SETTLEMENT UPDATE
FOR
MIDLAND PLANT UNITS 1 AND 2
CONSUMERS POWER COMPANY
DOCKET NUMBERS 50-329 AND 50-330

Report Date: September 14, 1980

NRC Position -- Diesel Generator Building
Vu No. 1 CPCo Position No. 1

List of Vugraphs for Diesel Generator Building

Vugra h 4

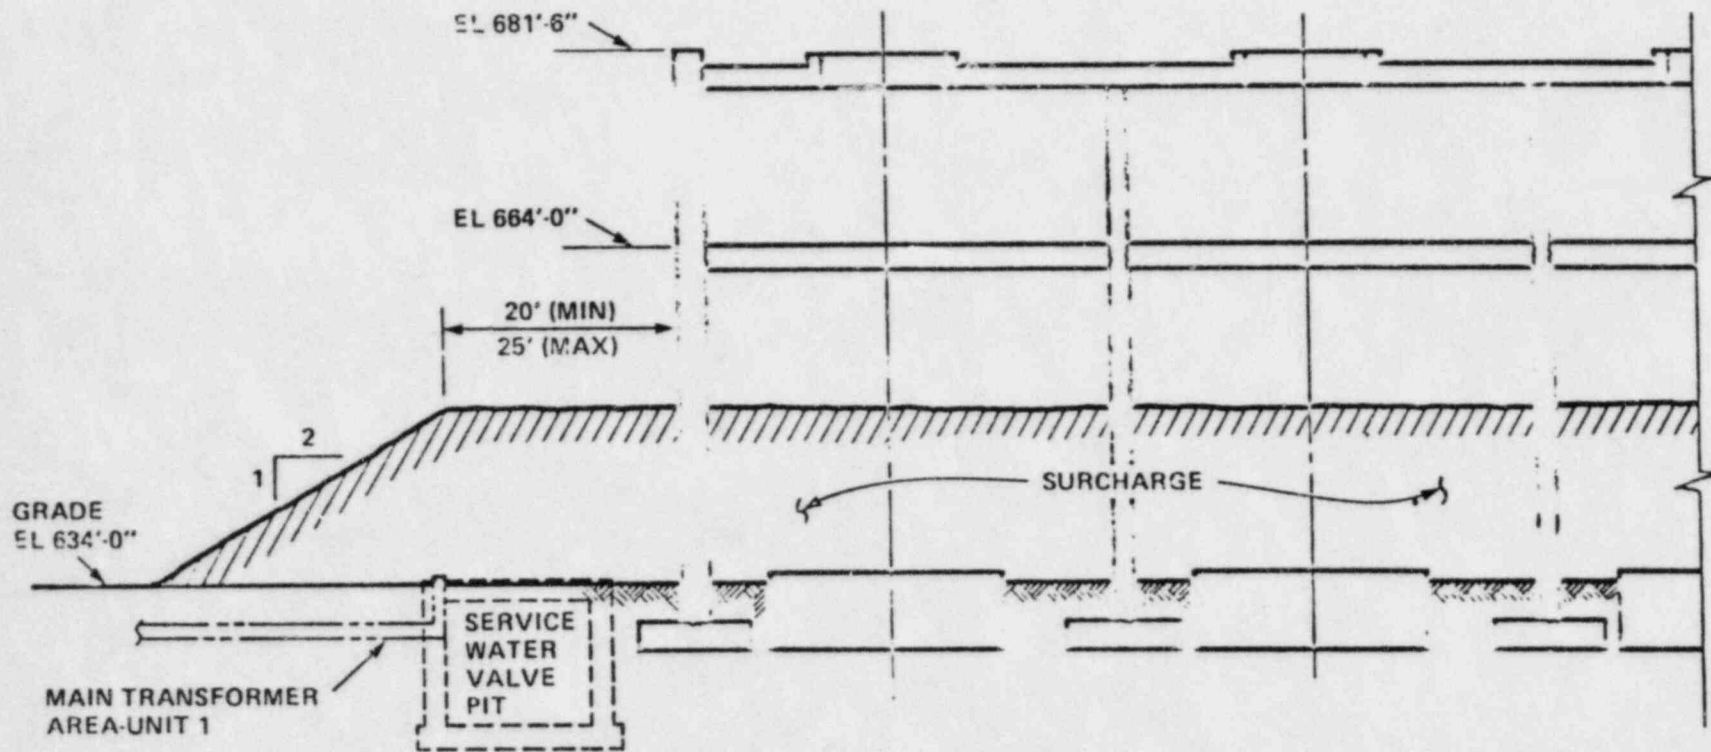
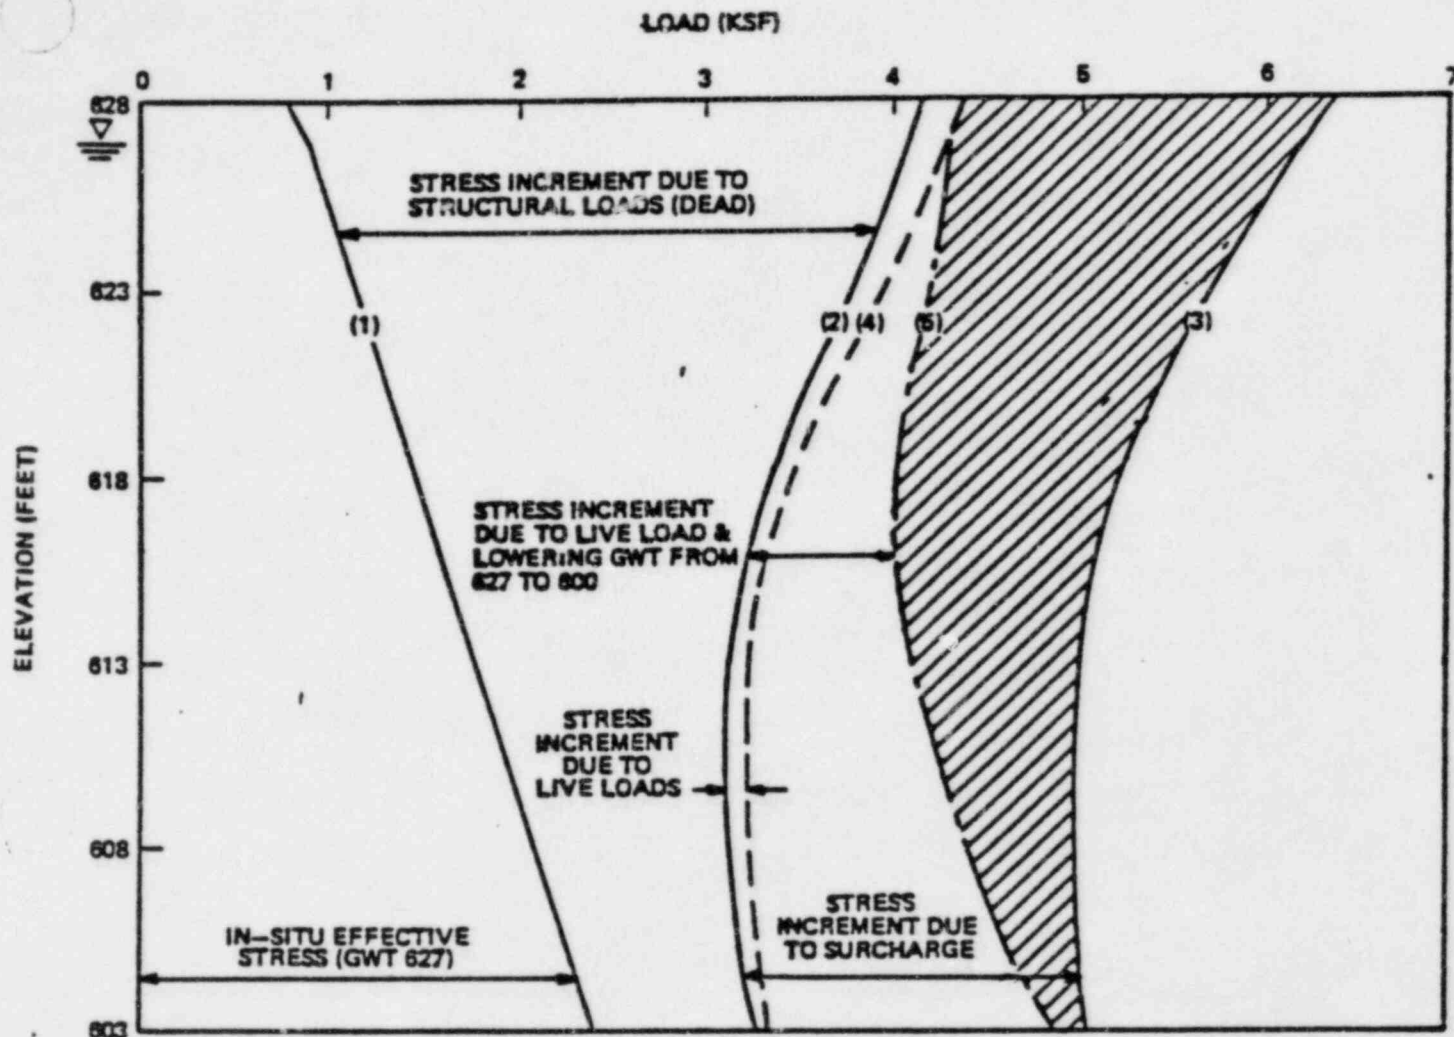
Sectional View A & B Vu No. 3 & 4 Point out depth of fill (30 ±)
Point out level to which we feel
GWT rose during surcharging

Vugraph No.5

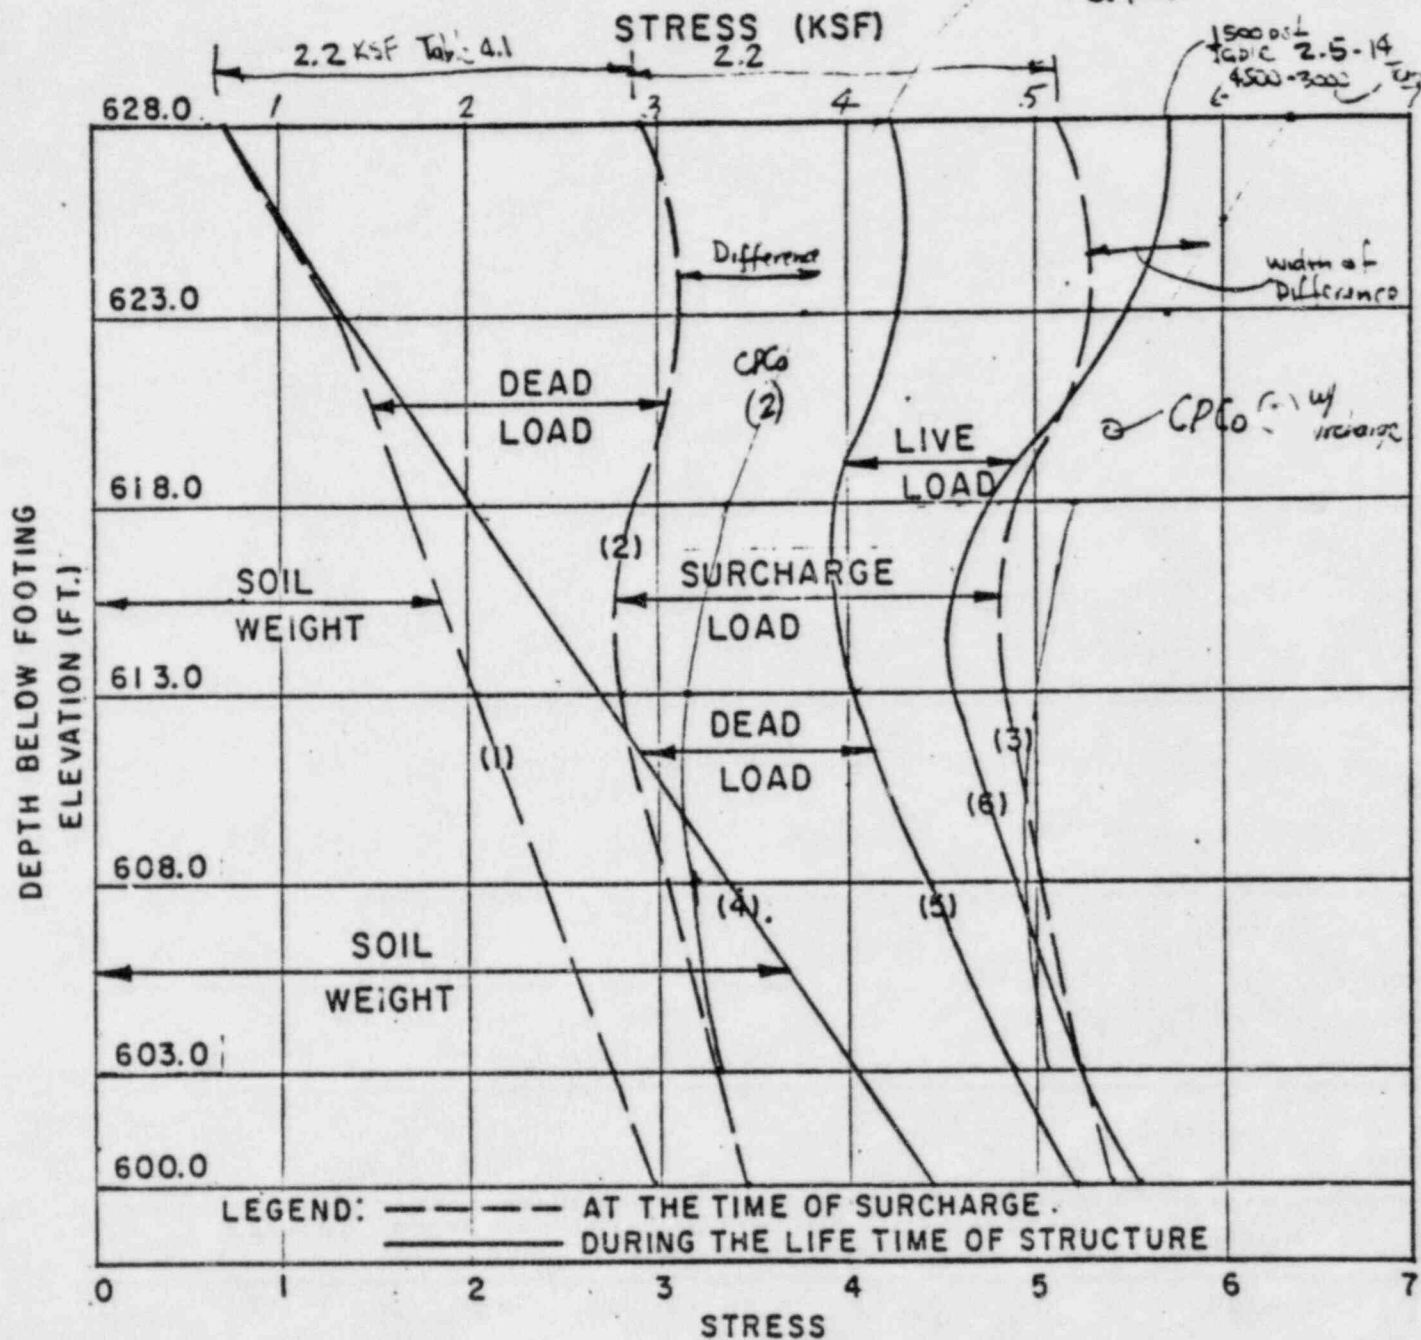
3. CPCo Position No. 2 concerning stresses produced in fill under surcharge
Vu No. 5

2. Surcharge produced stresses in the fill in excess of stresses to prevail while DGB is operational.
3. Settlement data recorded during surcharge program showed:

Vugraph No. 6

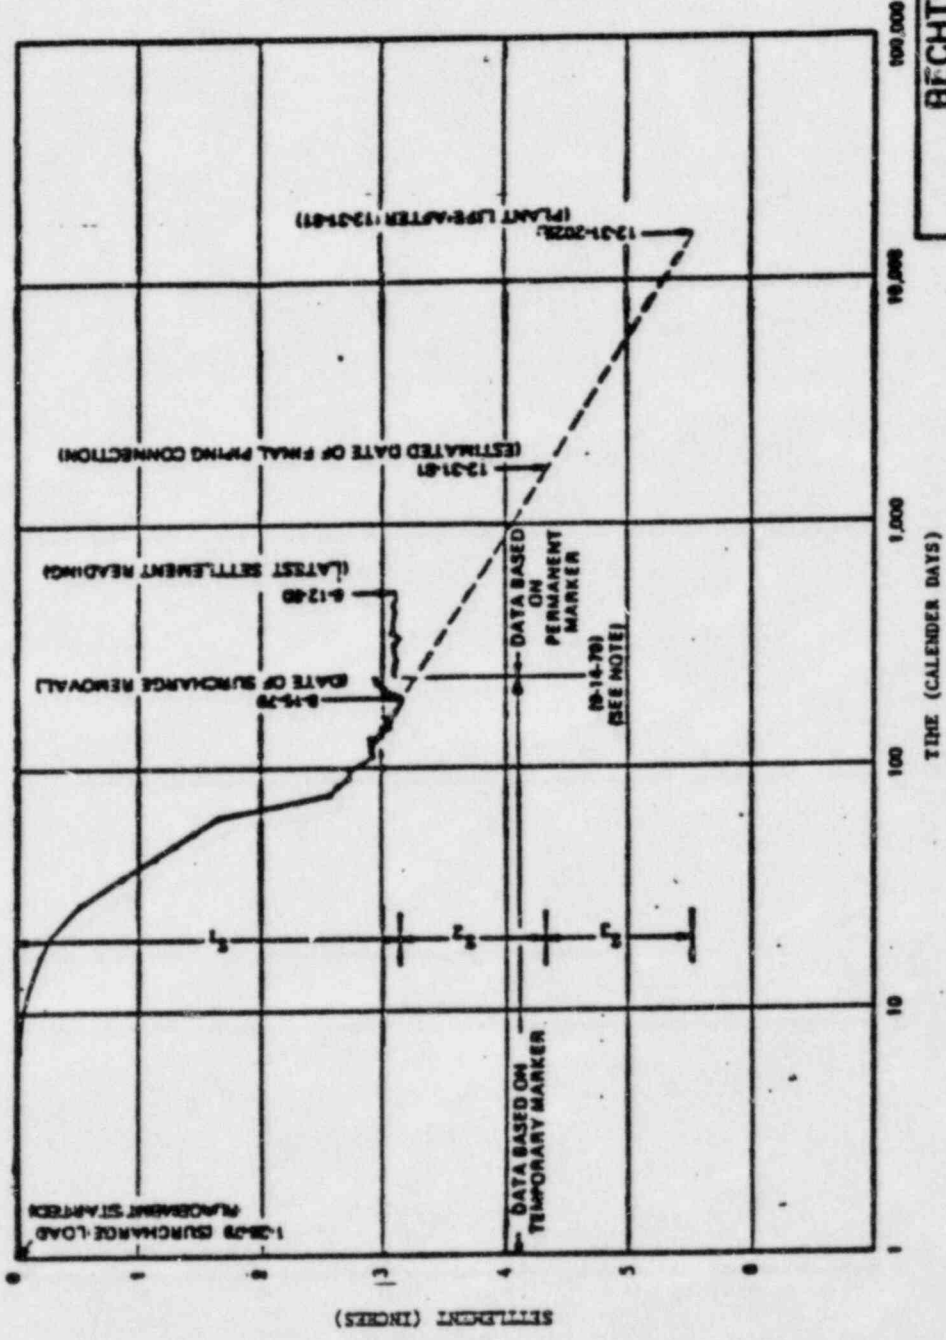
4. Staff Position - Vu No. 6
Surcharge load apparently just meets DL+LL+
Effect of Deaerating. Does not allow for additional environmental loads.
Normal practice in surcharge programs - Place a surcharge
load that is 1.5 times final load to assure secondary
consolidation is reached.

Yugraph No. 7

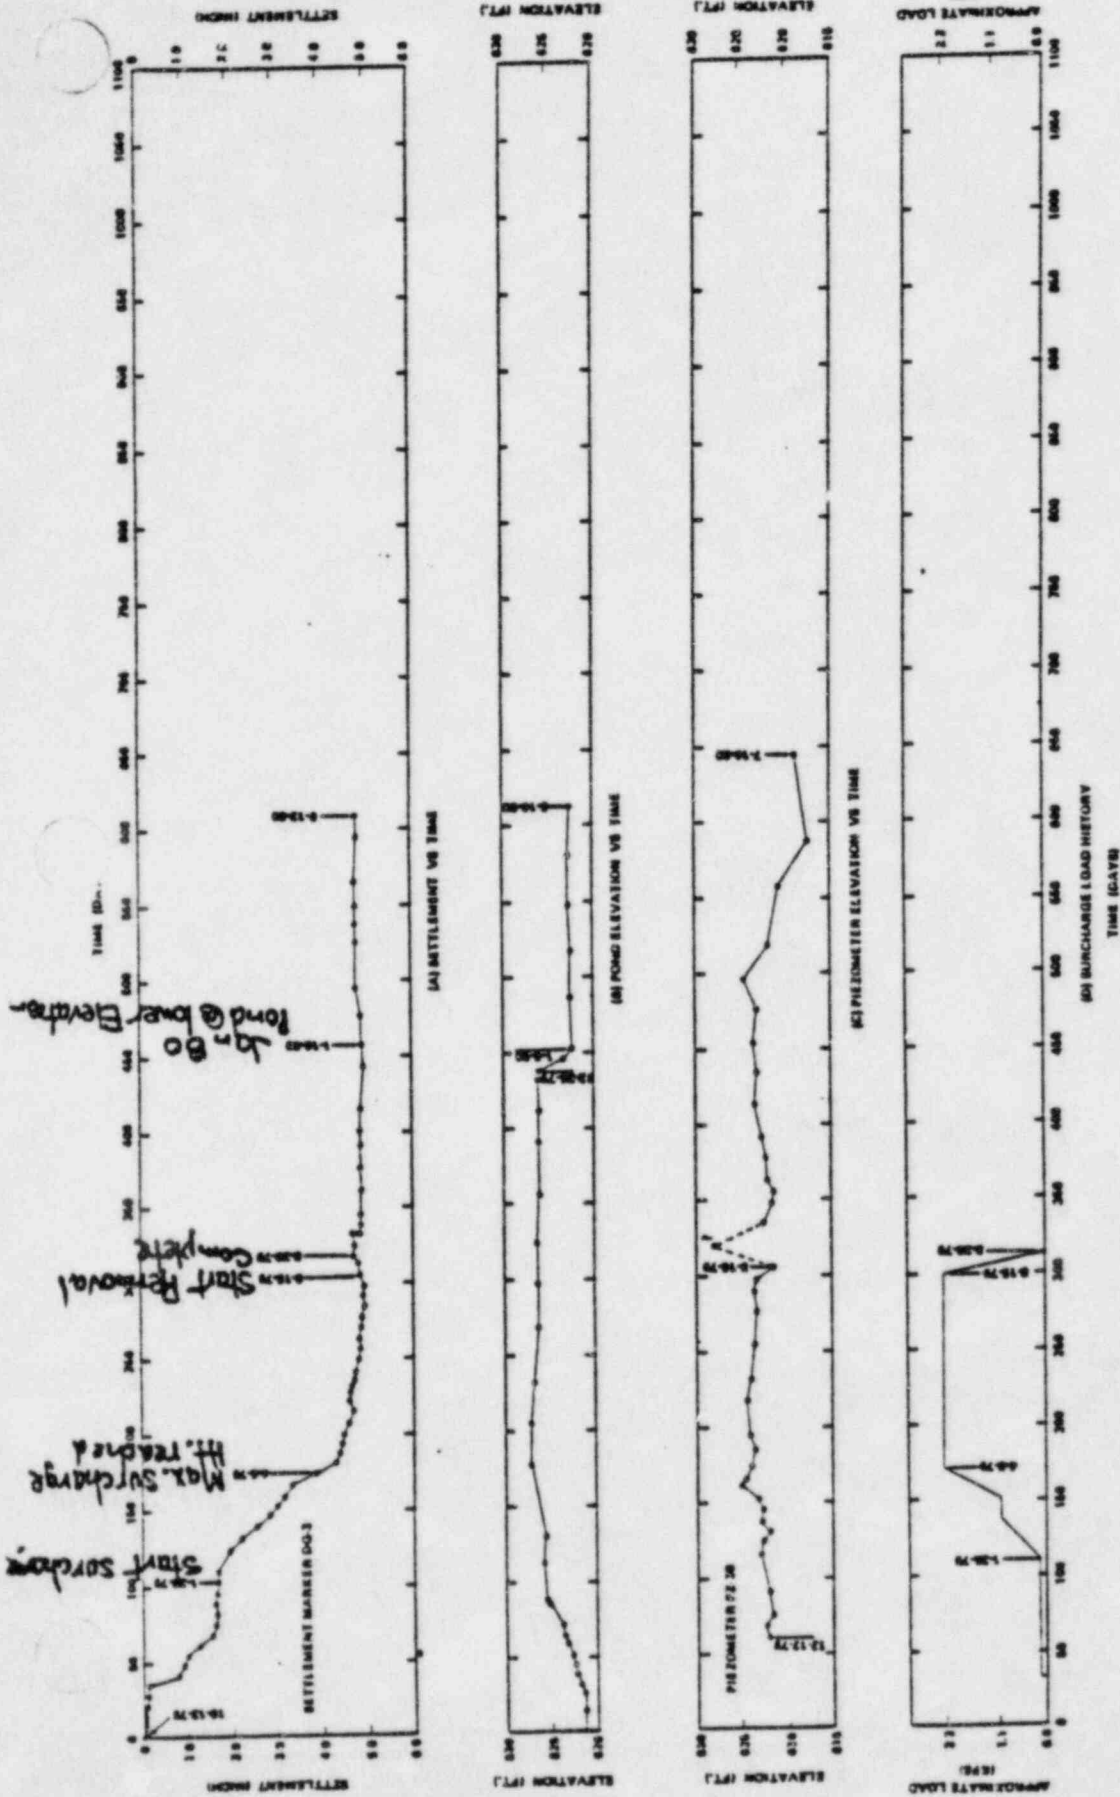
5. CPCo Position No. 3 **Vu No. 1** - Settlement Data
Vu No. 7 Presented by Dr. Peck at Aug. 29, 1980 meeting
- Shows decrease in rate of settlement after 100 days. Rebound.

- Time period where surcharge was imposed in secondary consolidation was approximately 90 days.
 - Note that graph conveniently plots only settlement after surcharge was placed.

Vugraph 8

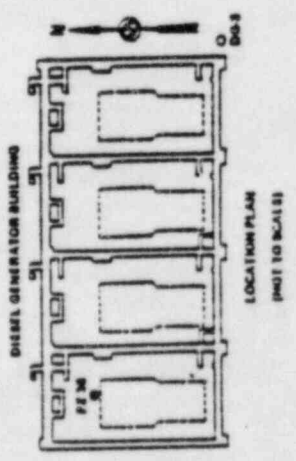
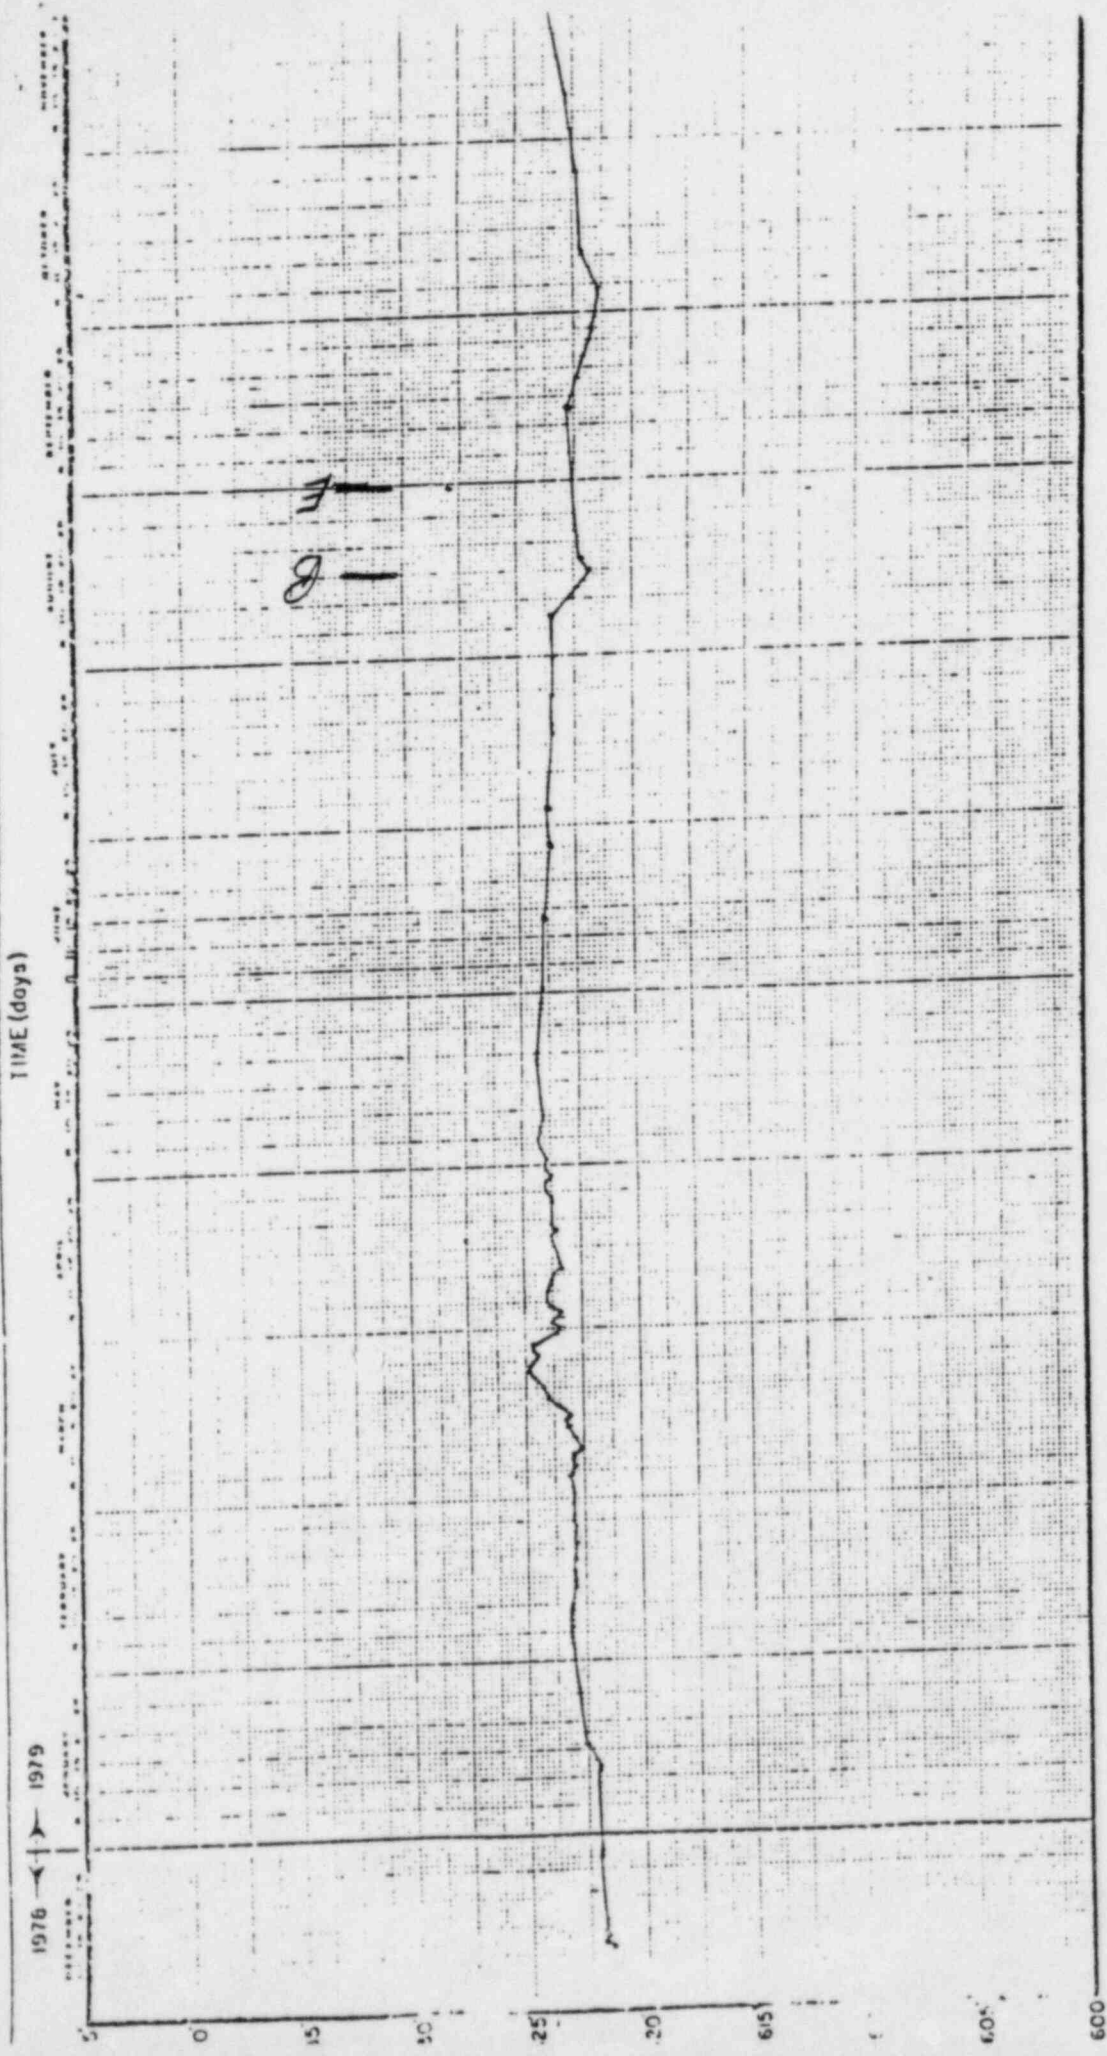
6. CPCo Position No. 4 **Vu No. 1** - Settlement & Piezometer Data
(Show **Vu No. 8**) Presented by Dr. Peck at Aug. 29, 1980 meeting
- Cover info presented (Settlement - arithmetic scale, pond levels, PZ-30 behavior (particularly after removal) & surcharge load history)
